# GE Hitachi Model No. 2000 Package RAI Discussion

Teleconference  
July 1, 2015

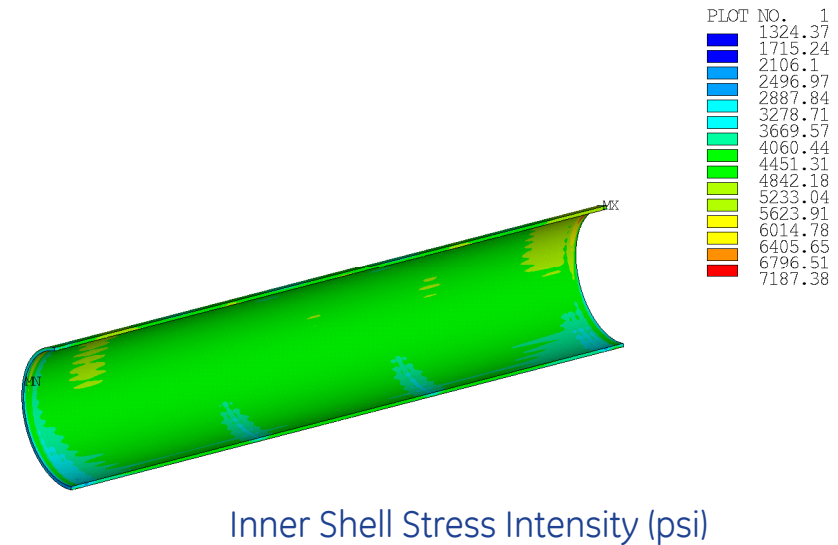
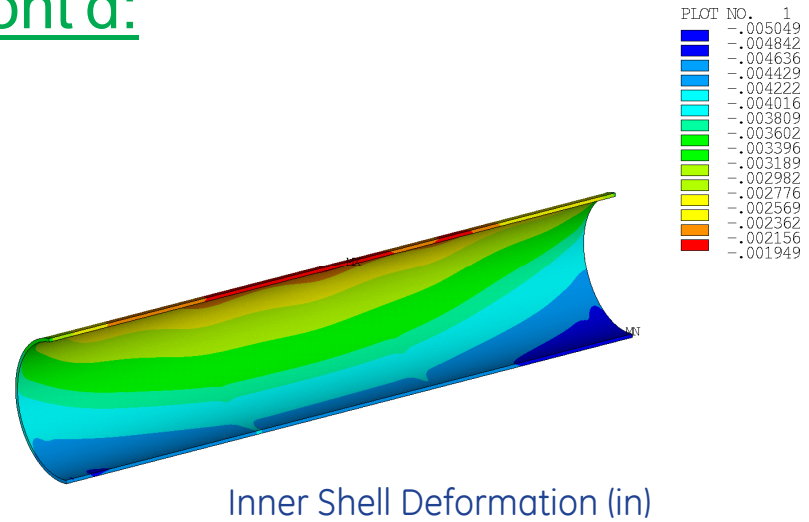
Justify the uniform equivalent static pressure assumption, along the High Performance Insert (HPI) axis, to represent the inertia load produced by the loaded Material Basket in determining margins of safety. If a line load assumption is considered, identify the stress acceptance criteria and corresponding margins of safety for the inner shell of the HPI subject to the normal conditions of transport (NCT) side-drop tests and conditions.

In Section 2.6.7.5, Boundary Conditions, drawing 001N8424 shows that the Material Basket is laterally supported by [[  
]]. As such, contrary to the “area load” distribution assumption, the HPI inner shell is expected to be subject to a “line load” at each of the [[  
]].

Two study runs were performed to show the difference between 4 line loads that represent the basket in contact with the HPI inner shell and a uniformly distributed load along the length of the basket.

Preliminary results show that the uniform pressure case results in a slightly higher stress than the 4 line load case (7285 psi versus 7187 psi). Review of the displacement results shows that the stresses in the inner shell are following classic beam theory.

A third study run will be performed to concentrate the load further at the center of the inner shell to determine if the trend continues.

Figure 3.1-1. Temperature-history of the Cask Ports for HAC

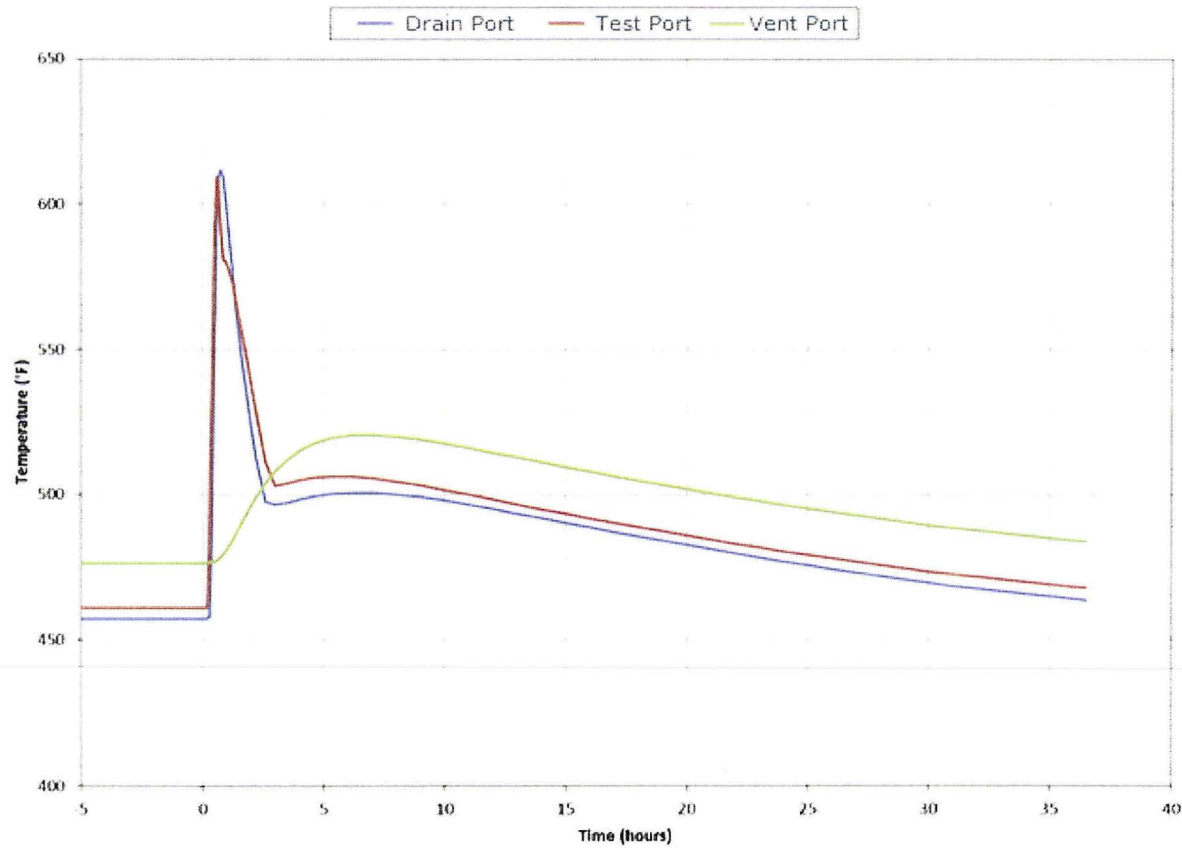
Provide the maximum temperatures of the O-rings located at test port, vent port and drain port, separately, under NCT and HAC.

As stated in SAR 1.2.1.1, GEH-2000 package has O-rings (made of [[  
]]) installed at the test port, vent port, and drain port. Instead of listing one “single” maximum temperature of cask seal in SAR Table 3-4 for hypothetical accident conditions (HAC) and Table 3-12 for NCT, the applicant needs to provide the maximum temperatures of the O-rings located at test port, vent port and drain port, separately. This information is necessary to confirm that the temperatures are in fact below their design limits under NCT and HAC. This information is needed to determine compliance with 10 CFR 71.71 and 71.73.

Using this revised solution methodology, the maximum temperatures of the ports are determined for both NCT and HAC. Tables 3.1-1 and 3.1-2 provide the NCT and HAC results, respectively. Figure 3.1-1 shows the temperature time-history of the port during the HAC fire and cool down.

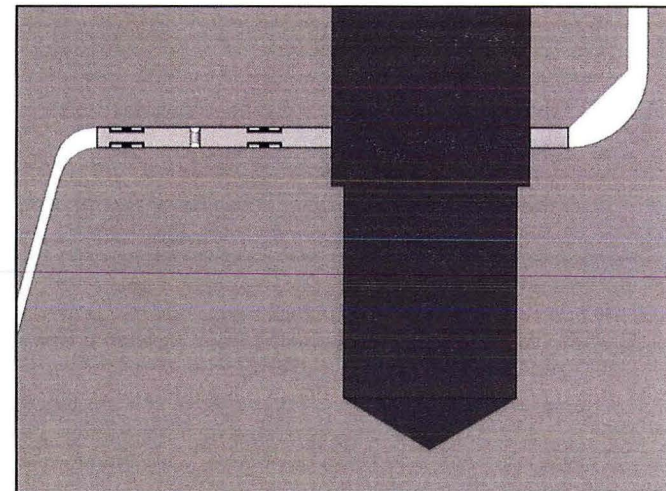
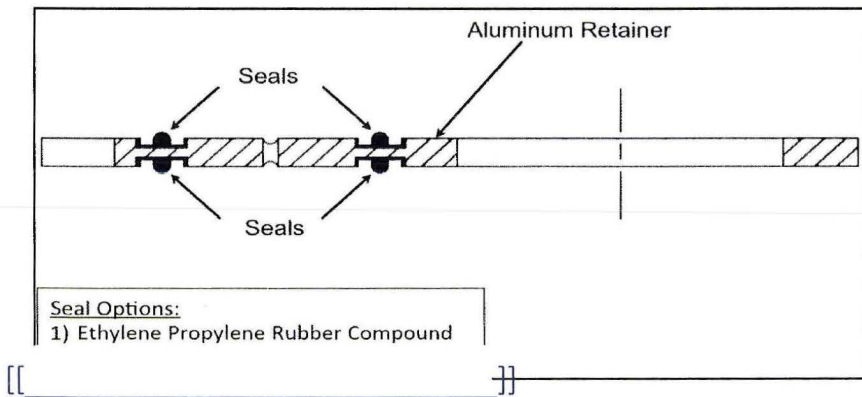
Provide the basis for the O-ring compression and O-ring groove dimensions in the drawings (i.e., from manufacturer data sheets).

The staff needs to verify the appropriateness of the seal for the containment system, therefore the basis for the O-ring compression and O-ring groove dimensions, such as from manufacturer data sheets, should be provided for the seals and the manufacturer and part number of the O-rings should be provided on the drawings.

The drawings should indicate both the dimensions and tolerances of the groove dimensions and the O-rings to ensure compression of the O-rings.

The dimensions and design for the “new” seals are identical to that of the seals that are currently licensed for the cask. For this application, the only change to the licensed seal design is a change of the [[ ]] material in the gasket seal and O-rings from the EPDM compound to the [[ ]] compound to accommodate the higher temperatures from the greater heat load. The information on the following two slides describes the gasket seal and O-ring designs that apply to both the old EPDM compound and the new [[ ]] compound.

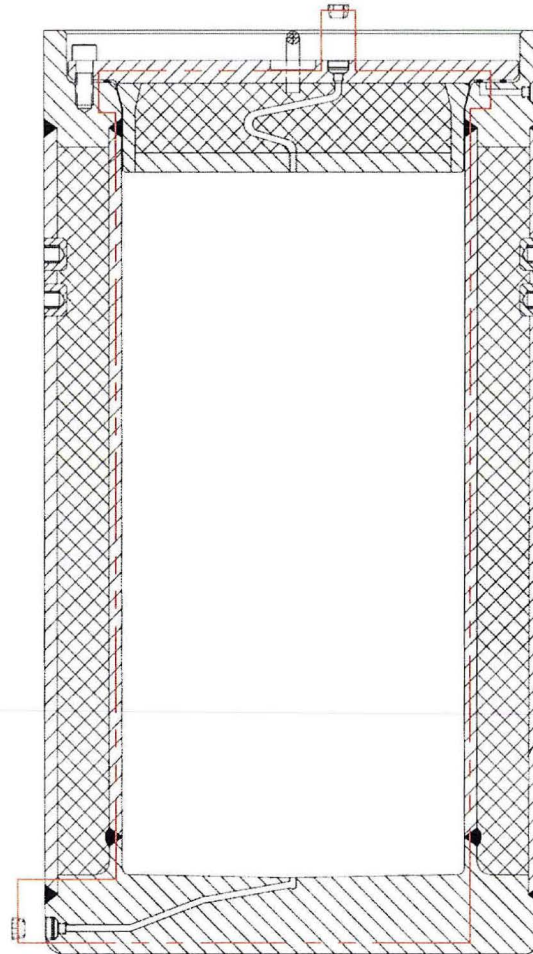
Identify seal and O-ring importance to safety category.

SAR Section 1.2.4 and 1.3.2 state that a new [[ ]] seals and O-rings will be used for the package but the seals and O-rings are not identified in a parts list.

All seals and O-rings should be identified on a parts list and their importance to safety category should be specified per NUREG/CR-6407, "Classification of Transportation Packaging and Dry Spent Fuel Storage System Components According to Importance to Safety."

**The gasket seal and port O-rings are all safety category A components.**

The new [[ ]] seal option is for the cask gasket seal and the O-rings in each of the 3 ports in the cask (vent, drain, and test ports). Per NUREG/CR-6407 the gasket seal and the O-rings used in the vent port and the drain port are classified as safety category A, as each are significant to maintaining the primary containment boundary. The image on the following slide shows the containment boundary, as outlined in drawing 101E8718, highlighted in red. The Test Port O-ring is outside of the inner seal of the gasket, making it outside of the primary containment boundary. Although this seal could be classified as safety category C, all port O-rings are safety category A as the O-rings are identical between the ports so the appropriate Quality records for safety category A components will be kept for all O-rings used for the cask.
